Technical Note TN.JS-019

17 February 2015

Canopy Frame/Canopy Latch Hinge Bolt Interference

As seen from the top:

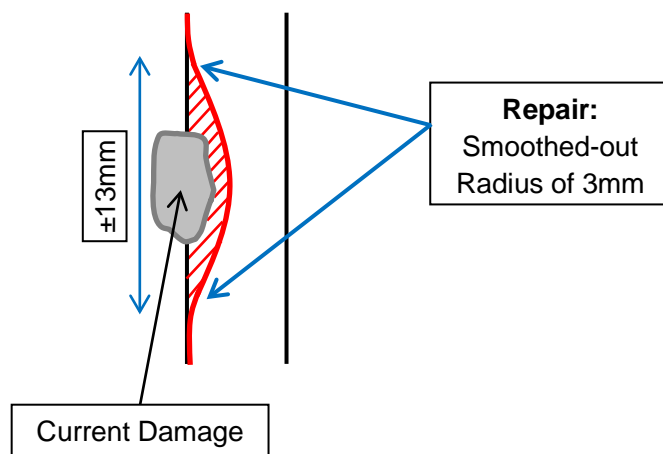
The lack of clearance between Canopy Latch Hinge Bolt (canopy frame side) and cockpit frame may cause witness marks or cosmetic damage to the cockpit frame. This Technical Note sets out a procedure to modify the cockpit frame to prevent possible interference.

1. Scallop the sharp edges of the damaged spot to a smooth radius of 3mm. The radius around the damaged area must be 2mm larger than the radius of the damaged area. Grind the entire thickness of the side frame away, as illustrated by the hatched-out area on the picture below.
